DPS CONTROL UNIT, fitting instruction	$\overline{}$	Model	Code	Page
	18.06.1997	6000-8400	39.21	1(3)

The earlier type control unit no 32861200 (tractors up to no 668102), will be replaced with a new unit no 33027100 and with an extra wire loom. The kit incl. also new fastening parts.

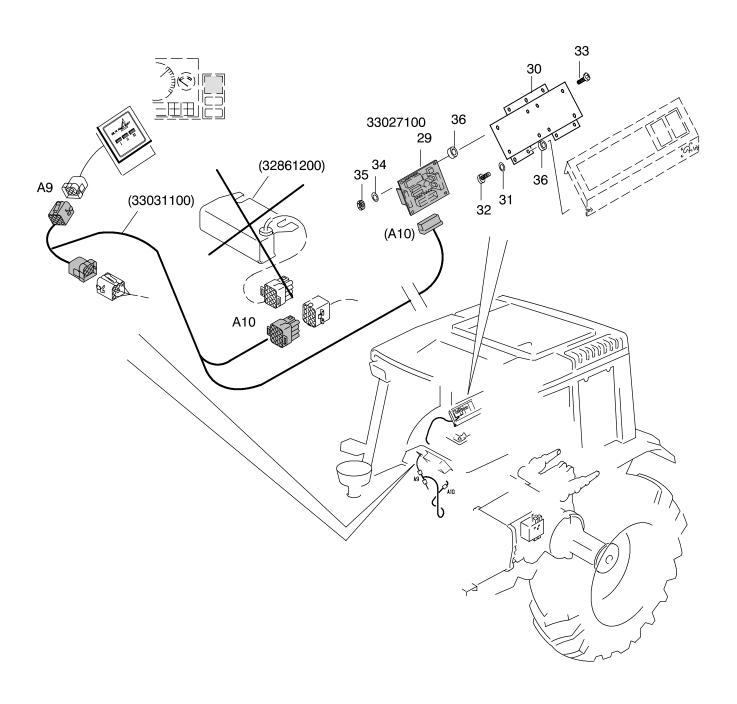
The earlier type control unit no 32861200 (tractors up to no 668102), will be replaced with a new unit no 33027100 and with an extra wire loom. The kit incl. also new fastening parts.

In connection with the unit change, the following functions are added:

- sound signal for applied hand brake
- sound signal for head lights

- Disconnect the battery earth lead.
- Remove the dash board plate round the instruments.
  - Push the connector end "A9" of the wire loom 33031100 into the steering wheel console from lower part upwards.

- Part the connector "A9" halves of the display unit and connect the wire loom 33031100 corresponding connector between the connector halves.
- Release the floor mat in the cab RH side front part and the lower end protection of the gear levers.

- Remove the earlier control unit (32861200). Remove the power lift switch panel. Unscrew the panel housing bottom nut. Loosen the door seal at the rear mudguard.

- Draw the wire loom 33031100 together with other cables along the floor into the lower end of the lever housing. Bind the cable together with the other cables.

- Connect the connector "A10" (in the cab wire loom to the loosened control unit) onto the new wire loom.
- Draw the new wire loom under the mudguard upholstery into the power lift switch panel housing (a hole for wires is ready—made).

- Fasten parts 29-36 onto the switch panel.
   Connect connector "(A10)" to the control unit circuit card and refit the cover. Fasten other removed parts.
